## Matthew Rosel - Submission Details for John Shawcross (object)

Submission for Job: #5878 SSD 5878-2013 Sydney International Convention, Exhibition and Entertainment Centre Precinct - Mixed use Development in the Southern Haymarket Precinct (Concept Proposal)  
[https://majorprojects.affinitylive.com?action=view\\_job&id=5878](https://majorprojects.affinitylive.com?action=view_job&id=5878)

# The inconvenient truth

7428A MCD AR D307 01/03/2013	DENTON CORKER MARSHALL	THE HAYMARKET LEND LEASE DEVELOPMENT	DEVELOPMENT APPLICATION PEAK TOWER - NORTH ELEVATION PROPOSED BUILDING PROFILE OVER
1:1000 @ A3 0 10 20 30

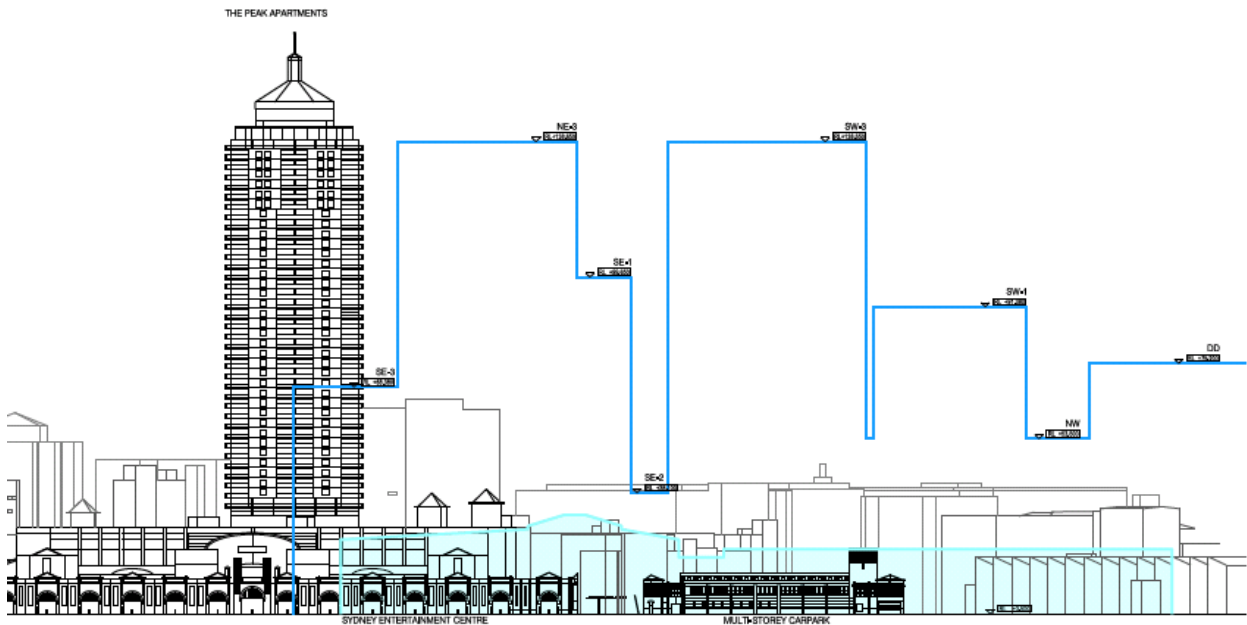
### 3. Parts that are relevant only to the Haymarket precinct are buried in the SICEEP DA.

Are these errors or just a convenient place to hide them ?

(e.g. SSD 5752, SICEEP, appendix O - visual and view impact analysis pt 61. Pdf)

*“Development application, Peak Tower, North Elevation, proposed building profile overlay*

The following figure – buried in SSD 5755 illustrates the size of the proposal in relation to The Peak.

I presume to hide the inconvenient truth.

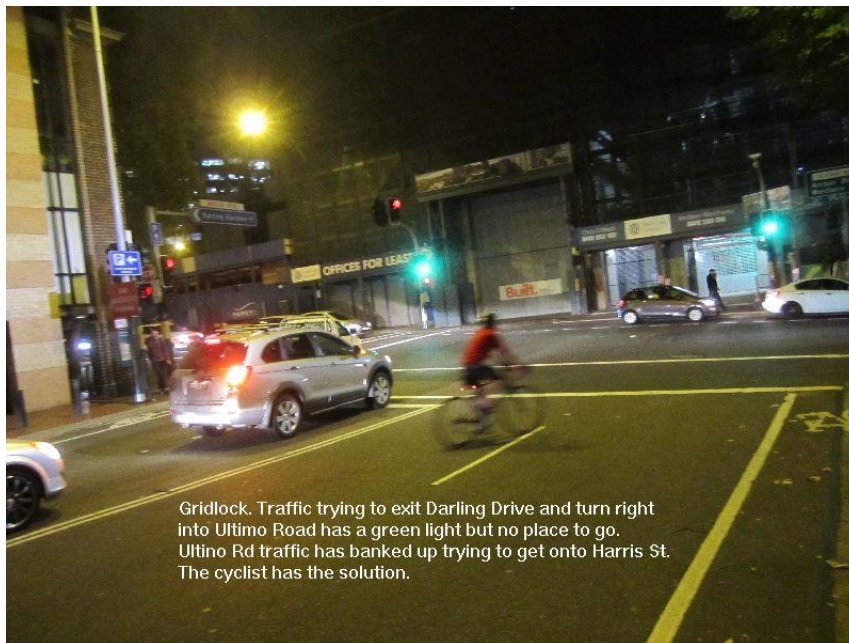
Darling Drive will be reduced to one lane each way EIS 2/4 P71: “ *Darling Drive has reduced the number of lanes and tightened the road corridor to provide a more attractive setting for the student accommodation*”

One of those is at Ultimo Rd, where the study states that *30% of the traffic flow to and from Darling Drive will be via Ultimo Road* (section 7.1.1). Yet amazingly no traffic studies are done on this intersection !

Gridlock. Ultimo Rd looking west towards Harris St.. Darling Drive enters from the right at the green light and trying to merge left to turn left into Harris St. No one going anywhere.

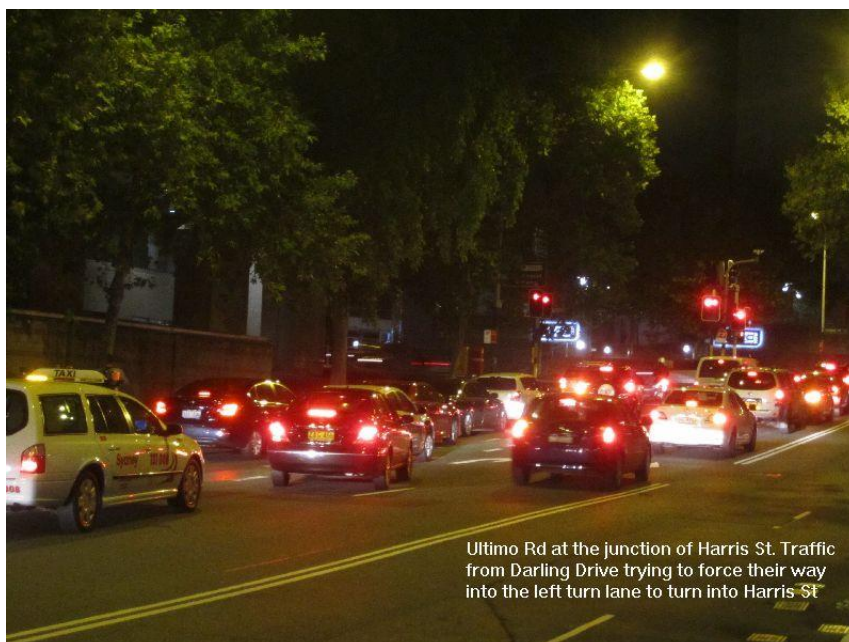
Gridlock. Traffic trying to exit Darling Drive and turn right into Ultimo Road has a green light but no place to go. Ultimo Rd traffic has banked up trying to get onto Harris St. The cyclist has the solution.

Ultimo Rd at the junction of Harris St. Traffic from Darling Drive trying to force their way into the left turn lane to turn into Harris St

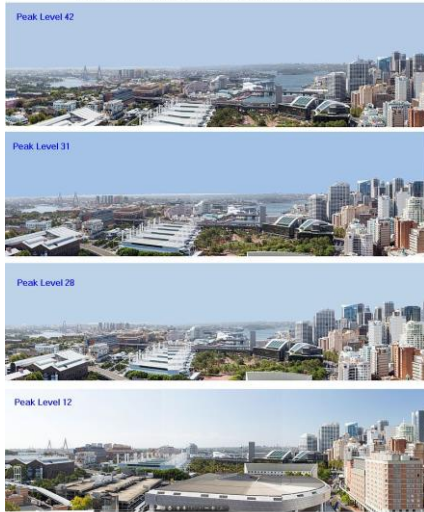
- Does not respect privacy and overlooking.

Peak Level 42

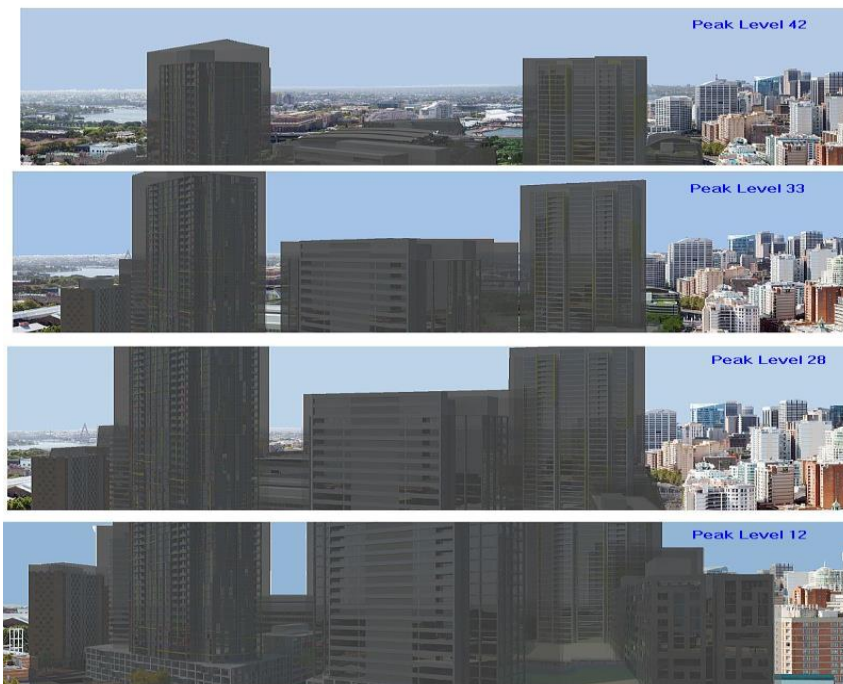
- Does not respect view sharing with existing buildings: 231 units in the Peak alone will lose an average of 60 degrees of views.
- Does not differentiate between new public views and new private views when preference should be considered for the **public** good.
- Proposes nine towers south of Pier St, where the Woods Bagot report suggests 2 and the City of Sydney recommends only 3
- Does not introduce setbacks for towers
- Does not allude to any concept of human scale

### The views we have today

### What we are going to see

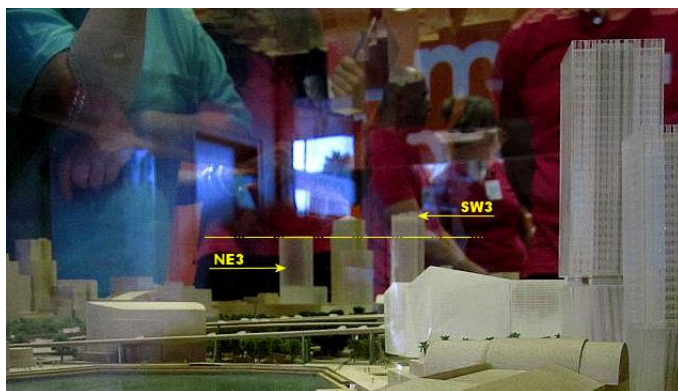
The information given during consultation was very much smoke and mirrors. The statements given on the height of the towers was vague and variable with the number of floors being defined from the podium level in some cases. The RLs of the top of the towers were not disclosed prior to the EIS being lodged. In fact tower NE3 grew about 8 floors after consultation.

This is clear from photos of the original model.
